Application Ref: NP/16/0679/FUL

Case Officer	Nicola Gandy		
Applicant	Bluestone National Park Resorts Ltd		
Agent	Mr L Page, Asbri Planning Ltd		
Proposal	Engineering works to facilitate the land train route from main resort centre, due north, to link with newly refurbished & extended car park to serve the Blackpool Mill proposal.		
Site Location	Blackpool Mill, Blackpool Bridge, Narberth, Pembrokeshire, SA67 8BL		
Grid Ref	SN06711386		
Date Valid	22-Feb-2017	Target Date	13-Dec-2017

Development Management Committee – 8th November 2017

Site: Bluestone National Park
Drawing No: Planning Note - Site Plan
Job No: Proposed Load Train Link between Bluestone Resort and Blackpool Mill
R359-BP-02c

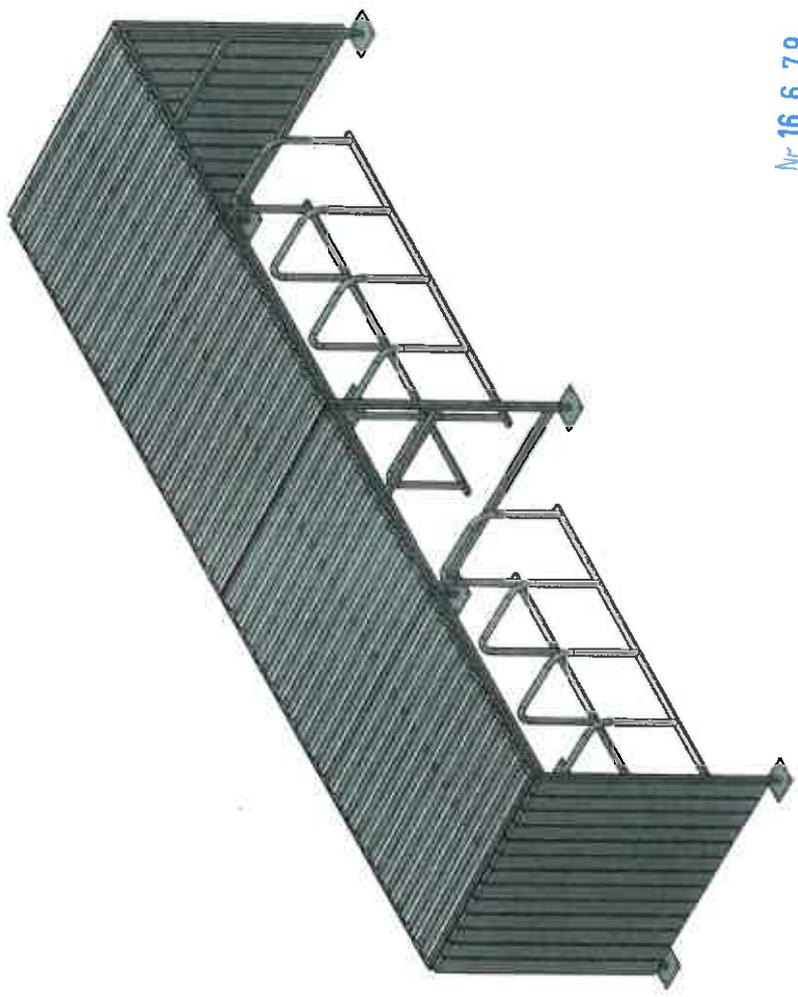
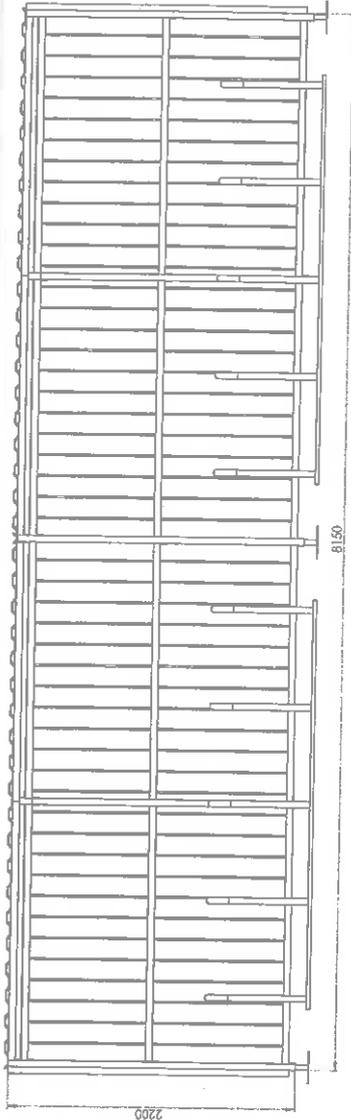
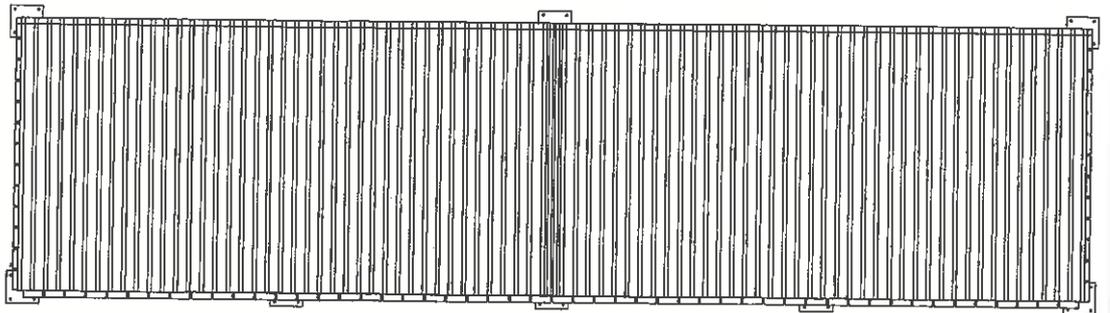
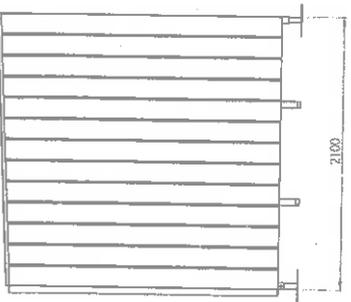
Natural Resources Wales: Advise that consideration is given to a minor amendment to the alignment of the land train route in order to retain the oak tree.

Lighting bollards are proposed every 18 metres of the route (in the lighting schedule) but every 17m on the submitted plans, and a covered cycle shed measuring 8.1 metres by 2.2 high by 2.1 wide is located adjacent to the proposed turning loop for the train.

The application has not included a survey of trees which will be impacted by the proposed foundations of the trackway. At 4.6 metres width with a depth of 1 metres, tree roots may be negatively impacted by the proposed engineering works, for which no assessment has been made. A survey may illustrate that alternative engineered details are required and should thus be produced prior to determination to either establish that there will be no harm to the trees along the route or that an alternative engineering solution needs to be designed. Based on the potential harm to a number of mature trees along the route, the application cannot be supported and fails to comply with Local Development Plan Policies 8, 11 and 15.

Confirmation is required to establish if the trees identified as having moderate to high potential are to be retained or removed as part of the proposed development. If they are to be removed further activity surveys will be required prior to determination to assess levels of use, species present and produce a suitable mitigation strategy.
